Offshore Special Regulations – 3.11 Sheet Winches

Interpretation 02-2022 Offshore Special Regulations

Effective date: 16/11/2022

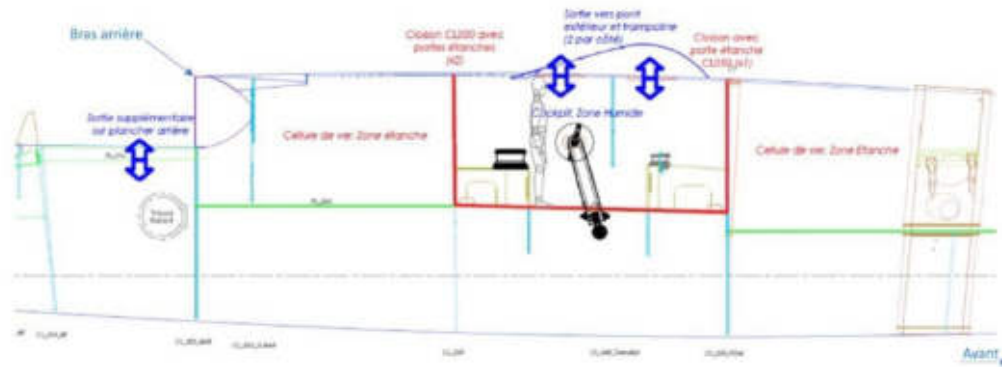
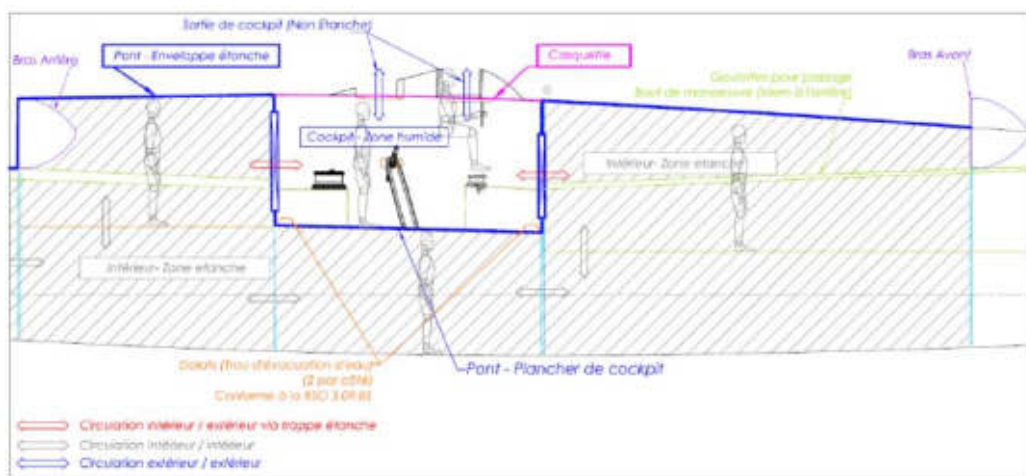
1. *In this example of layout, would the component marked “pont de travail” be considered to be deck?*

2. *If the answer to Question 1 is “yes” could any part of this component be considered not to be deck?*

3. *If the answer to Question 1 is “yes”, does this example of cockpit layout comply with OSR 3.11?*

Yes.

No. However, other parts of OSR, such as 3.07 must also be considered with regards to the assembly of this part.

No.
